THREE MILE ISLAND UNIT II  
TWG

NUMBER TP 360/1C

RADIATION MONITORING SYSTEM EST-

AREA MONITORS

FIGURE NO. 3 POWER SUPPLY VOLTAGE MEASUREMENTS ON THE REMOTE ALARM UNIT

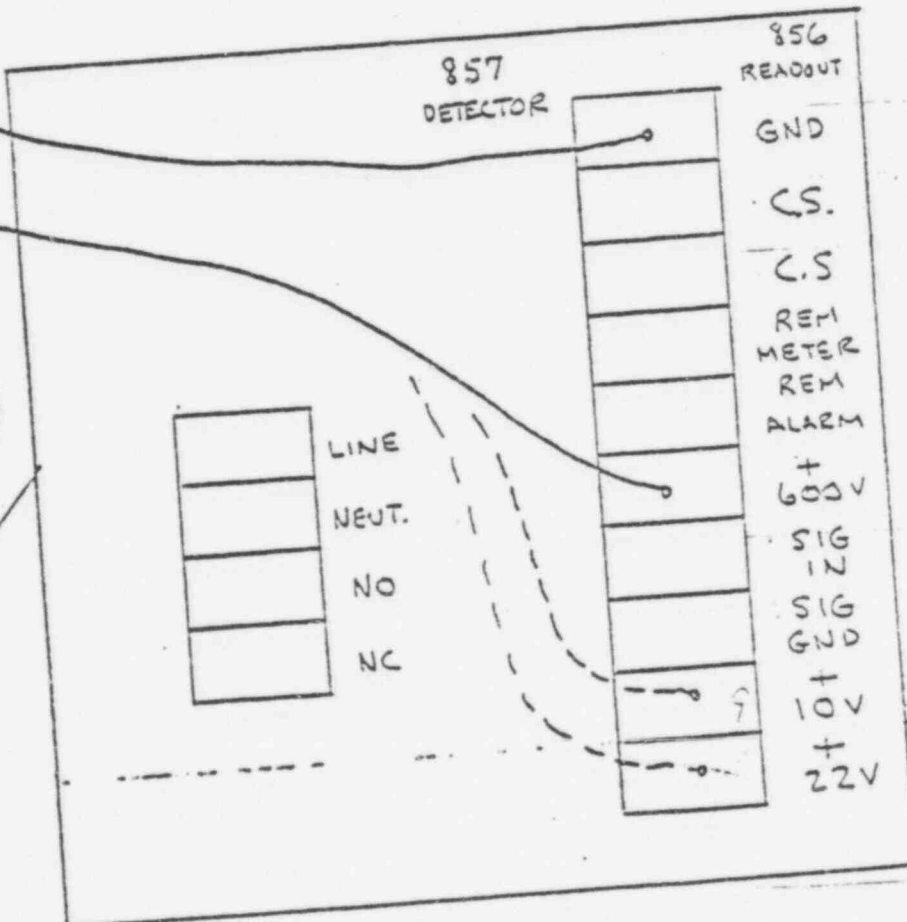
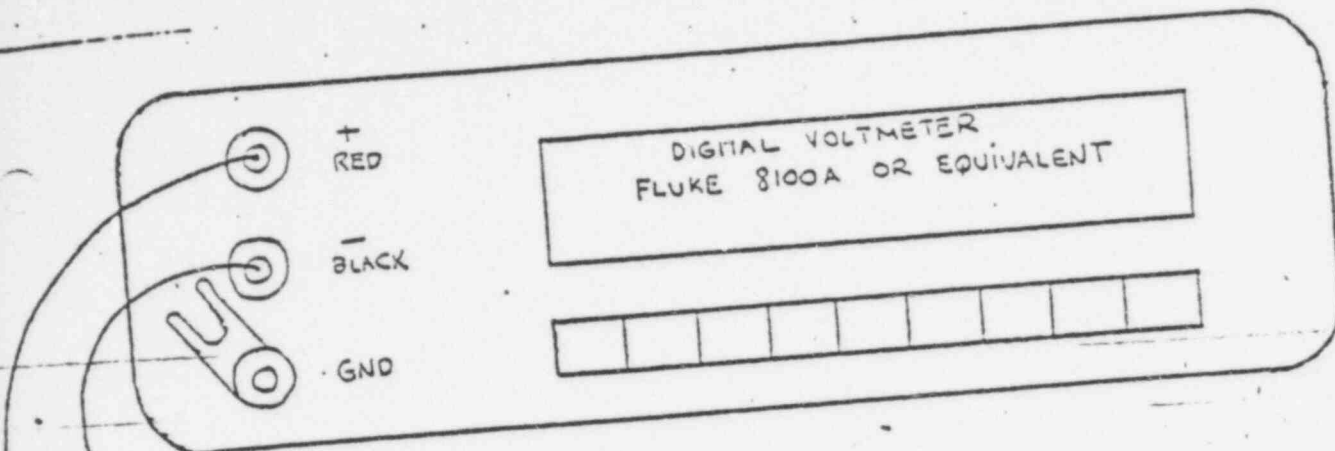
No.	E/D	Par.	Description/Initial/Date	Justification/Resolution	Justified/ Completed Signoff	Date
8	E D	9.2.2 Encl. 2 Fig. 3	Fig 3 of Enclosure 2 is incorrect. JAB 1/8/78	In order to ensure that the proper connection is made when taking readings refer to Victoria Tech. Manual for correct location of terminal point described. JAB 1/8/78	JAB	1/30/78
9	E	9.4.4 7.4.9	R534R54 should not be adjusted unless replaced in accord with Vico. JAB 1/26/78	Adjust R37 to vary - adjust high alarm setpoints	JAB	1/26/78
10	E	Encl. 4	R.B. Evac. Alarm not off HP-2205, 210, 205 JAB 1/26/78	Design deletion by B+R JAB 1/26/78	JAB	1/26/78
11	E	9.9.3	No projected reading 1/27/78	Done to establish baseline data	JAB	1/27/78
12	E	9.11.3	This is not a wall mounted device. JAB 1/27/78	Detector located in pit on top of elevator shaft. Detector should just be replaced in pit. JAB 1/27/78	JAB	1/27/78
13	D	9.11.5 9.7.9 10.13	Scale only goes to 10 <sup>4</sup> on recorder. JAB 1/27/78	Victoria to supply updated scale .1 to 10 <sup>4</sup> and .1 to 10 <sup>7</sup> for HP recorder. JAB. Submitted Work Request 2761	JAB	3/16/78

FIGURE NO. 3 POWER SUPPLY VOLTAGE MEASUREMENTS ON THE REMOTE ALARM UNIT

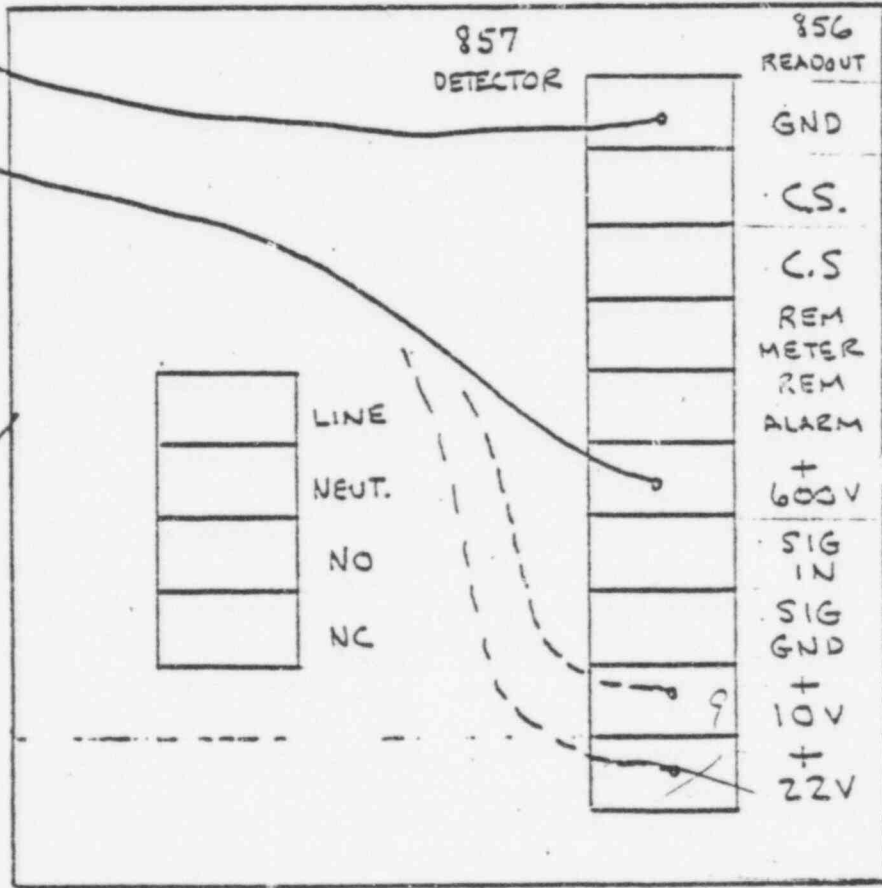
No.	E/D	Par.	Description/Initial/Date	Justification/Resolution	Signoff	Justified/Completed Date
8	E JTB	9.2.2 Encl. 2 Fig. 3	Fig 3 of Enclosure 2 is incorrect. JTB 1/8/78	In order to ensure that the proper connection is made when taking readings refer to Vietnam Tech. Manual for correct location of terminal point described. JTB 1/8/78	JTB	1/30/78
9	E	9.4.4 7.4.7	R53 & R54 should not be originated unless replaced in record with Vico. JTB 1/26/78	Adjustment R37 to vary about high column setpoints	JTB	1/26/78
10	E	Encl. 4	R.B. Elec. Alarm not off R53, R205, 210, 215. JTB 1/26/78	Design deletion by B+R JTB 1/26/78	JTB	1/26/78
11	E	9.9.3	No projected reading 1/27/78	Done to establish baseline data.	JTB	1/27/78
12	E	9.11.3	This is not a well mounted device. JTB 1/27/78	Detector located in Pig on top of elevator shaft. Detector should just be replaced in place. JTB 1/27/78	JTB	1/27/78
13	D	9.11.5 9.7.7 10.13	Scale only goes to 10 <sup>4</sup> on recorder. JTB 1/27/78	Vietnam to supply updated scale .1 to 10 <sup>4</sup> and .1 to 10 <sup>7</sup> for HP recorder. JTB. Submitted Work Request 2761	JTB	3/1/78

*E*  
~~12-8~~  
*ab*

FIGURE NO. 3 POWER SUPPLY VOLTAGE MEASUREMENTS ON THE REMOTE ALARM UNIT

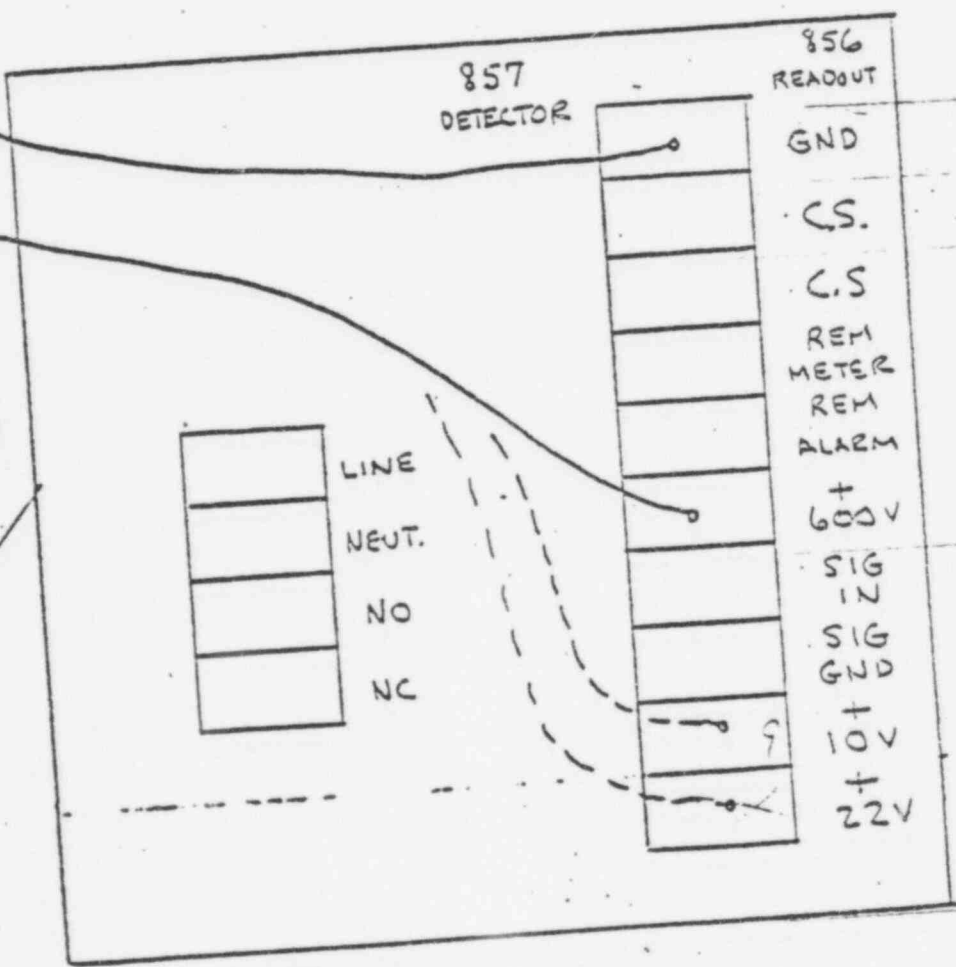
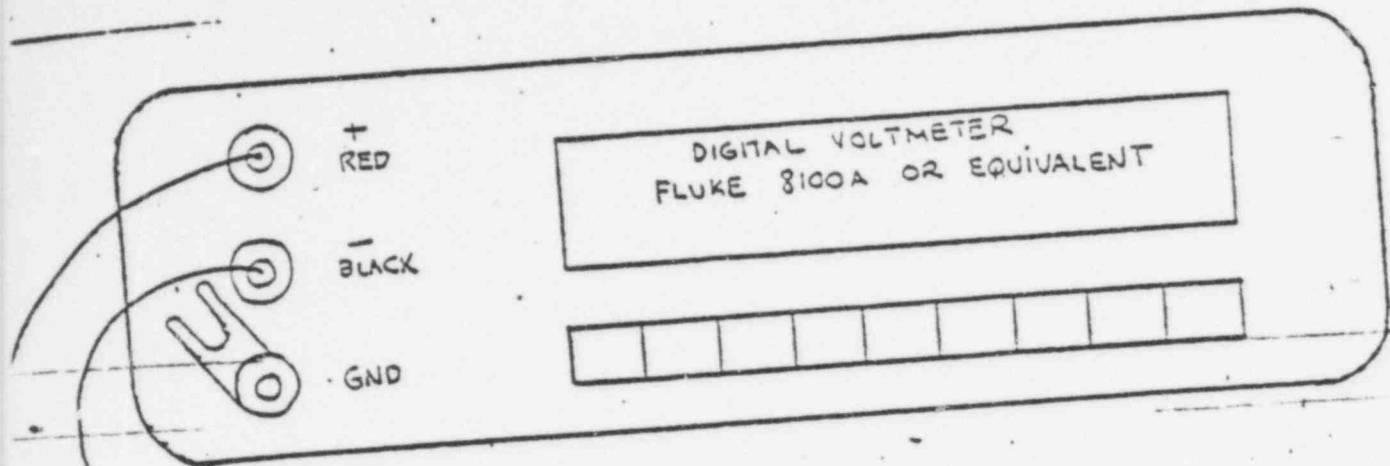
No.	E/D	Par.	Description/Initial/Date	Justification/Resolution	Signoff	Justified/ Completed Date
8	<i>E</i> <i>D</i> <i>W</i>	9.2.2 Encl. 2 Fig. 3	Fig 3 of Enclosure 2 is incorrect. <i>JAB 1/8/78</i>	In order to ensure that the proper connection is made when taking readings refer to Victorian Tech. Manual for correct location of terminal point described. <i>JAB 1/8/78</i>	<i>JAB</i>	1/30/78
9	<i>E</i>	9.4.4 7.4.9	R53 4R54 should not be adjusted unless replaced in accord with Vic. <i>JAB 1/26/78</i>	Adjustment R37 to vary about high alarm setpoints	<i>JAB</i>	1/26/78
10	<i>E</i>	Encl. 4	R.B. Exec. Alarm not off HP. R-209, 210, 205 <i>JAB 1/26/78</i>	Design deletion by B+R <i>JAB 1/26/78</i>	<i>JAB</i>	1/26/78
11	<i>E</i>	9.9.3	No projected reading 1/27/78	Done to establish baseline data	<i>JAB</i>	1/27/78
12	<i>E</i>	9.11.3	This is not a wall mounted device. <i>JAB 1/27/78</i>	Detector located in pit on top of elevator shaft. Detector should just be replaced in pit. <i>JAB 1/27/78</i>	<i>JAB</i>	1/27/78
